From: [Norman Huff](#)
To: [FCGMA](#)
Subject: Comments on the First Periodic Evaluation, Groundwater Sustainability Plan for the PVB
Date: Monday, October 7, 2024 1:54:10 PM
Attachments: [20241007 SUBMITTED CWD COMMENTS ON PVBGSP EVAL.pdf](#)

Re: Comments on the “First Periodic Evaluation, Groundwater Sustainability Plan for the Pleasant Valley Basin”

**COMMENTS ON “FIRST PERIODIC EVALUATION, GROUNDWATER SUSTAINABILITY PLAN
FOR THE PLEASANT VALLEY BASIN” DATED August 2024**

Attachment A
Comparison of UWCD Calibrated Models
Original Ventura Regional Groundwater
Flow Model (1985-2015) and Coastal Plain
Model (1985-Sep 2022)

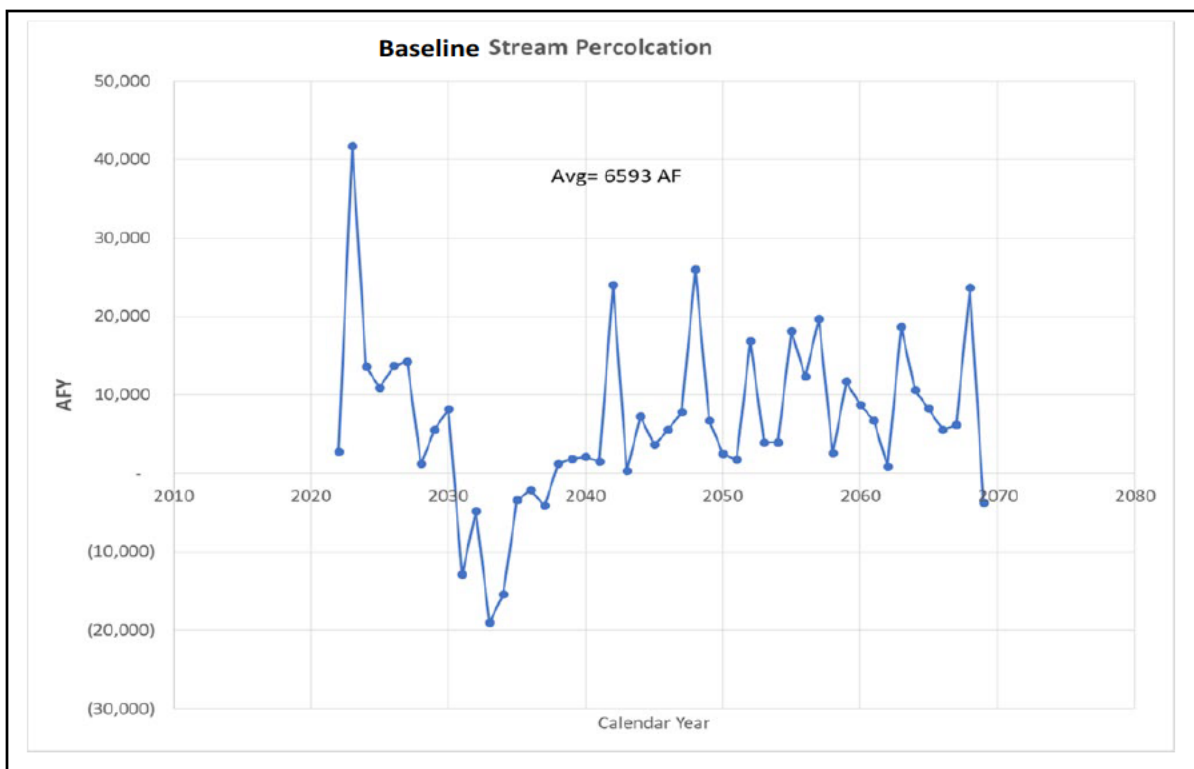
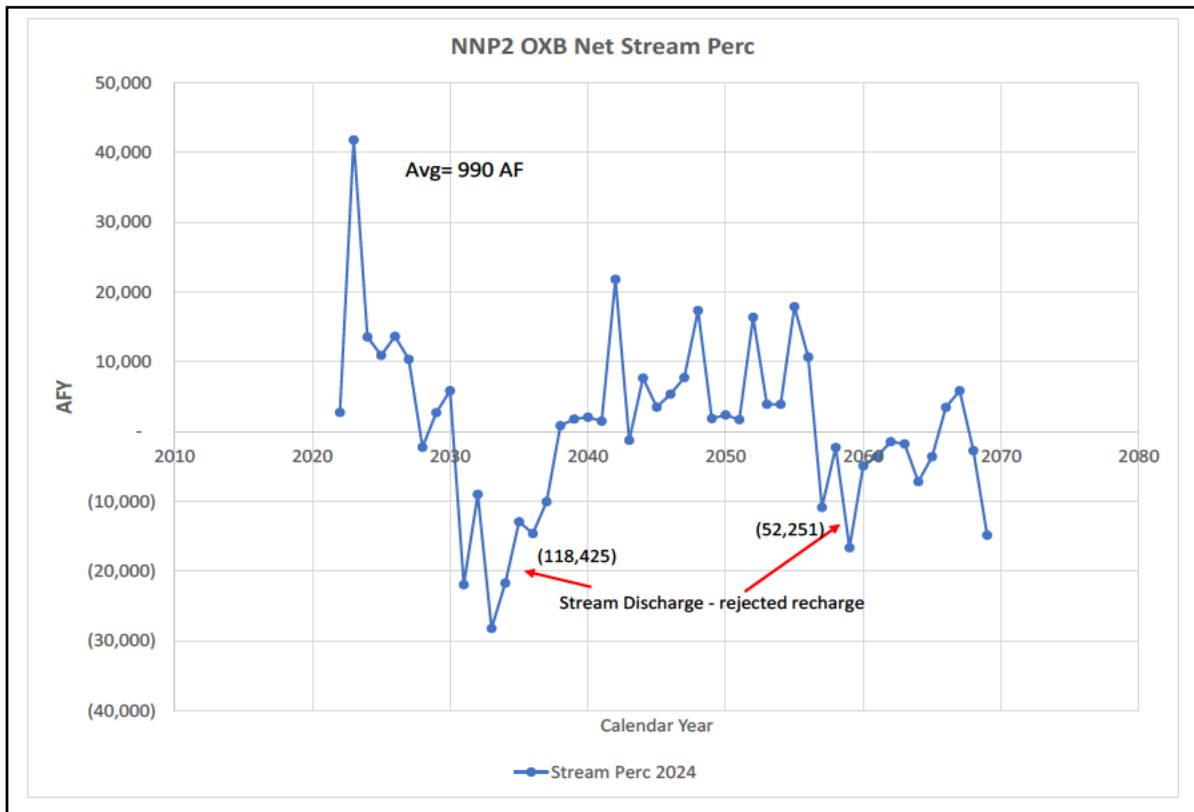
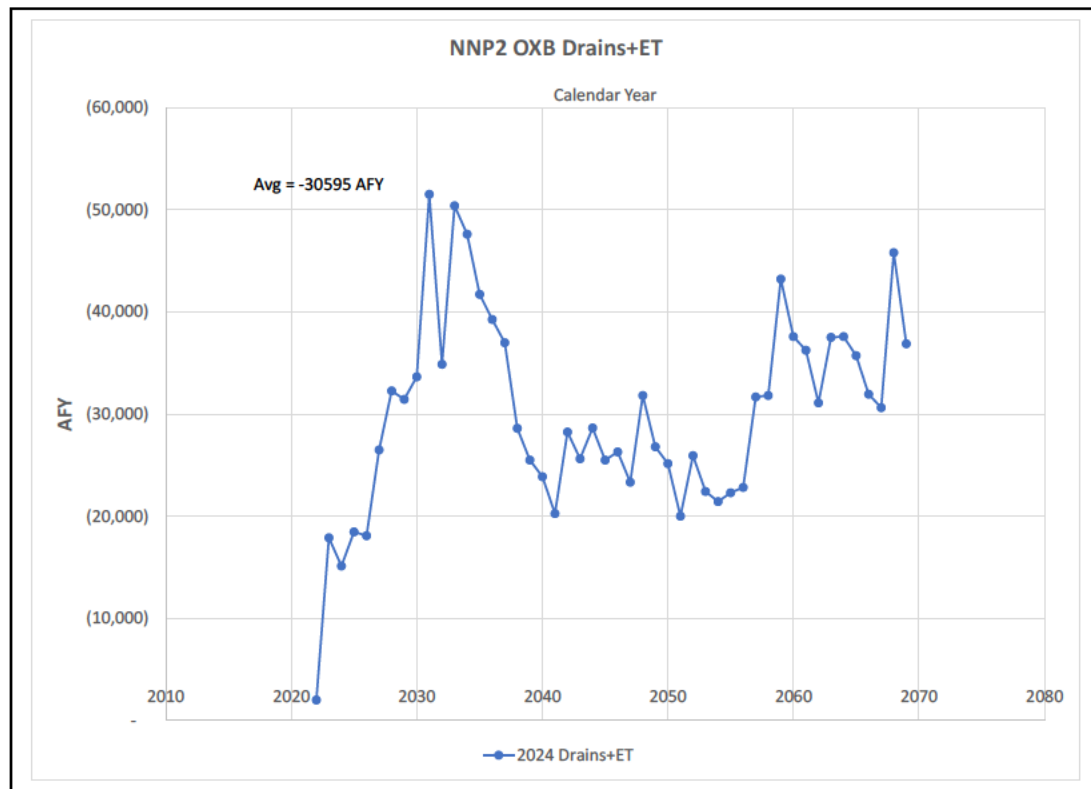
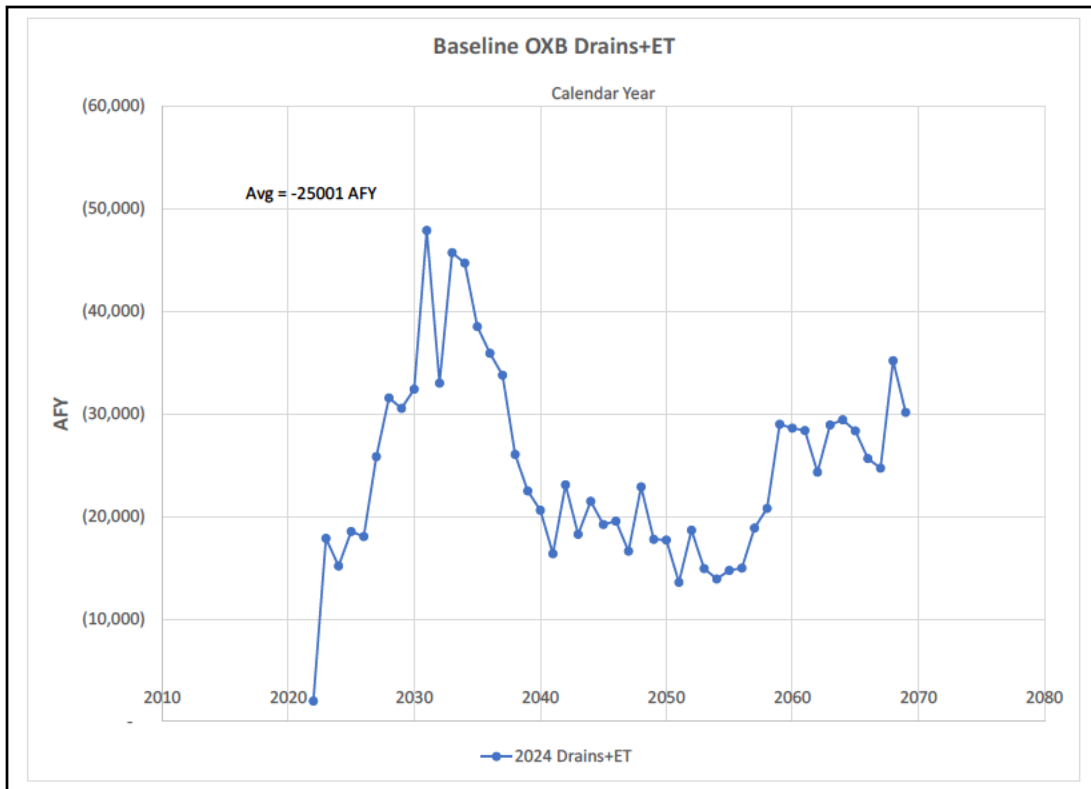
2. Interaquifer flow from the UAS to the LAS is substantially reduced in the Oxnard Subbasin as shown in the two plots below. In the Future Baseline scenario, an average of 20,960 AFY flows from the UAS to the LAS and in the NNP2 scenario, this average flow is reduced to 9,560 AFY, a reduction of about 11,400 AFY.

3. The groundwater flow reversal from L1 to UAS and substantial reduction in flow from UAS to LAS does not go to offset coastal inflows as desired. Instead, groundwater flow takes the path of least resistance and in response to local hydraulic gradients, is redirected to discharge into the Santa Clara River and discharge to drains and surface ET as shown in the four plots below. Net stream percolation is reduced by an average of 5,600 AFY, which instead discharges down the Santa Clara River.

As shown in the two plots above, groundwater flows to drains and ET increases by about 5,600 AFY. So, over 11,200 AFY goes to discharges to the Santa Clara River, drains and ET. This number dwarfs the 3,800 AFY of interbasin groundwater flows to the West Las Posas Basin and PVB.

Storage

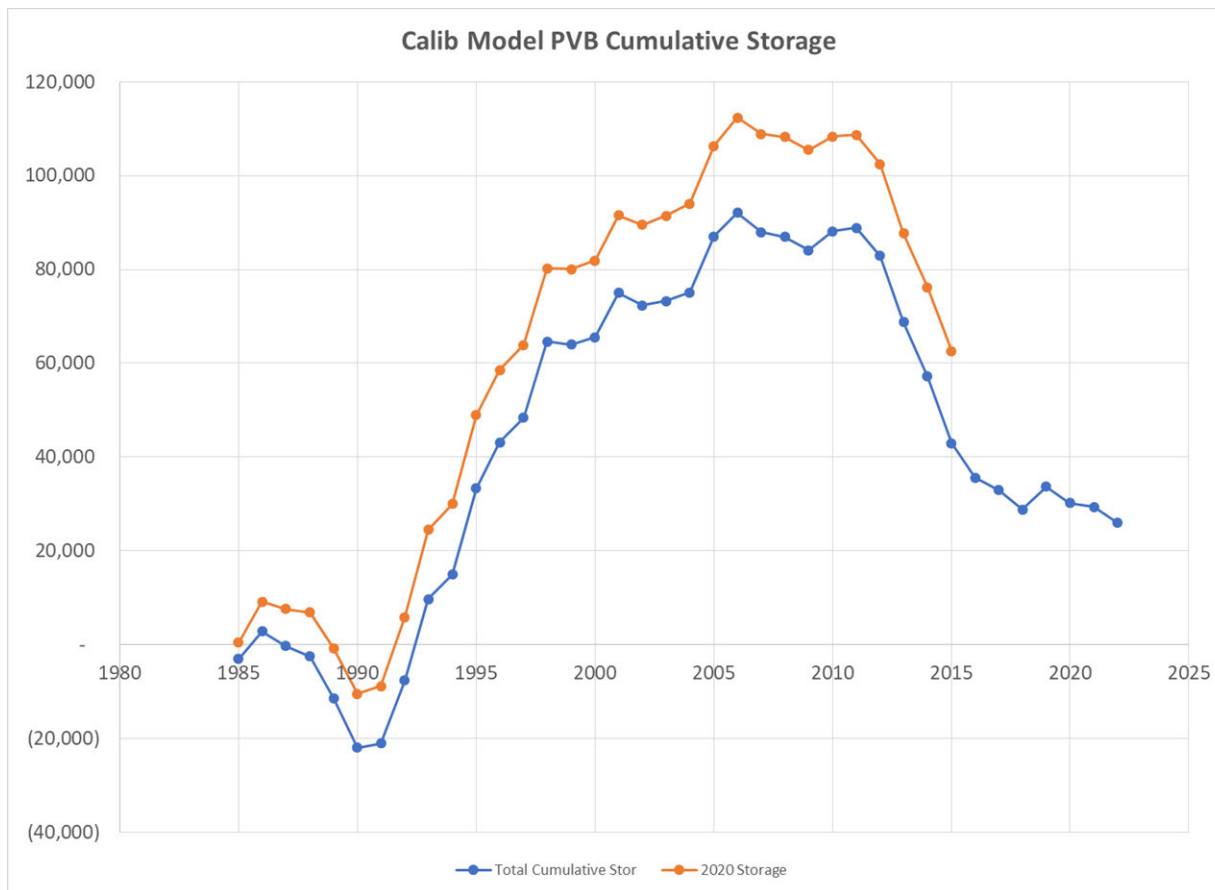
Difference is almost solely due to more ET in 2024 model
